RE: Ironwood Real Estate, LLC/Etown IRE Associates, LLC
1551 South Market Street - Subdivision Plan

PRELIMINARY/FINAL SUBDIVISION PLAN

PENNSYLVANIA CVS PHARMACY, L.L.C.
#1551 SOUTH MARKET STREET
PARCEL #460-6300100000

Re: Ironwood Real Estate, LLC (1551 South Market Street)
Minor Subdivision Plan
Township Permit No. 25-16-MSDP
LCEC Project No: 25-203

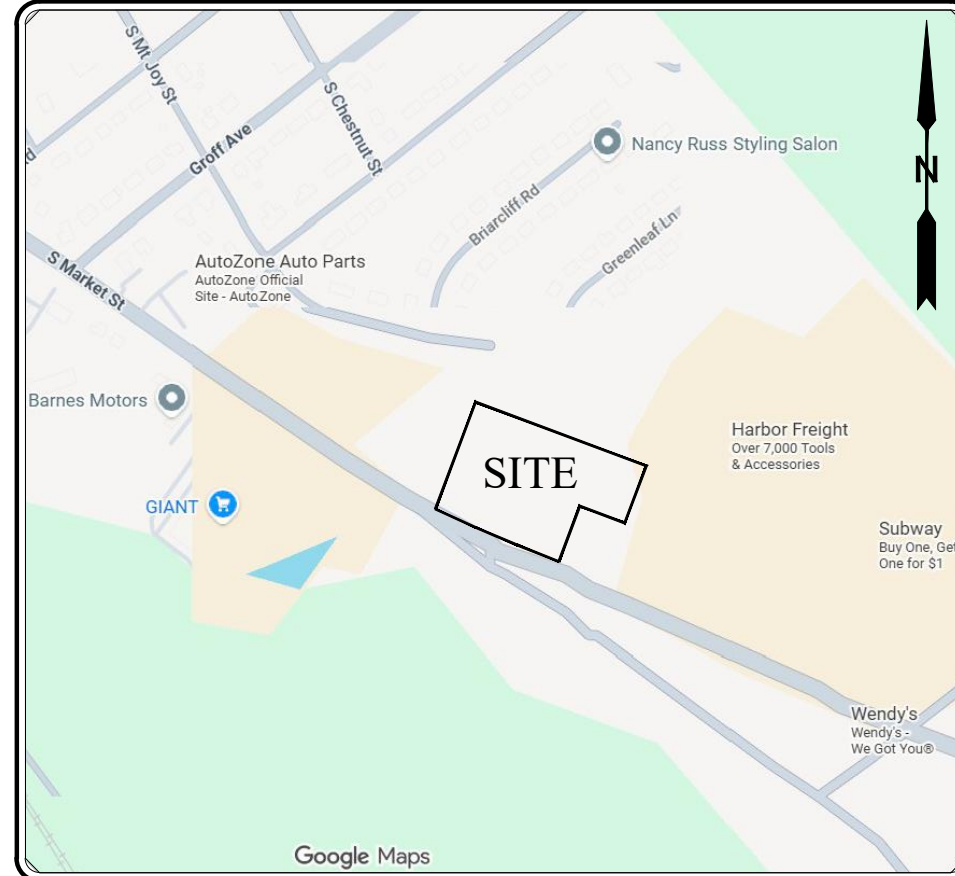
1. The maximum height requirement shall be added to the Zoning Data table (135-135.A).

2. All off-street parking lots shall be set back at least 15 feet from the side and rear lot lines (135-135.E(2)(c) & 135-135.E(3)(b)). These setbacks should be shown on the plans.

5. Riparian corridors shall be established to include 30 feet on each side of the watercourse, measured from the top of each stream bank (135-306.B). The applicant shall enter into a recordable agreement with the Township providing for the permanent maintenance of the riparian corridor, in a form acceptable to the Township Solicitor (135-306.F).

6. The total required number of spaces for the retail store use (i.e. shopping center) shall be corrected (135-343.C). The required number of parking spaces may be reduced by 20% for joint parking lots (135-344.A).

21. The existing stream on the subject tract shall be shown on the plans (119-31.C(5)).

1. The maximum height requirement shown in the Zoning Data table shall be corrected (135-135.A).
2. The existing impervious coverage exceeds 65%. This is an existing non-conformity. However, the proposed impervious coverage for Proposed Lot 1 (75.8%) exceeds the existing, non-conforming impervious coverage (70.7%); this would require a variance from the Zoning Hearing Board (135-135.F(2)).
3. Clear sight triangles and stopping sight distances shall be shown at the existing access points (135-299.E(2) & 119-31.D(12)). The applicant appears to have requested a waiver of this requirement since this requirement is listed in the "List of Waivers" on the Cover Sheet; however the response letter does not state a waiver is being requested.

5. The total required number of spaces for the retail store use (i.e. shopping center) shall be corrected (135-343.C). For 33,870 sf of gross floor area, 169 parking spaces would be required (5 spaces per 1,000 sf of floor area). The required number of parking spaces may be reduced by 20% for joint parking lots (135-344.A)
6. A calculation showing the number of seats and employees shall be provided for the parking space requirements for the Drive-Through Restaurant use (135-343.C(5)).
7. A cross access easement and maintenance agreement that ensures the common use of, access to, and maintenance of the joint-use parking lot for proposed lots 1 and 2. The agreement shall be provided in a form acceptable to the Township Solicitor (135-344.C).
8. Off street loading space information shall be shown on the plans (135-346).

25. The proposed property corners symbols shall be labeled to differentiate between the different types of corners to be set (119-57.B & 119-57.D). It currently appears that concrete monuments are to be set at each corner; however, there are three different “proposed property corners” symbols shown in the legend.

The maximum height requirement has been added to the subdivision plan.

The parking setbacks have been added to the subdivision plan.

A proposed riparian corridor has been added to the subdivision plan. The applicant will enter into a riparian corridor maintenance agreement prior to subdivision plan recording.

The required number of parking spaces for the shopping center has been reduced by 20%.

The existing stream has been added.
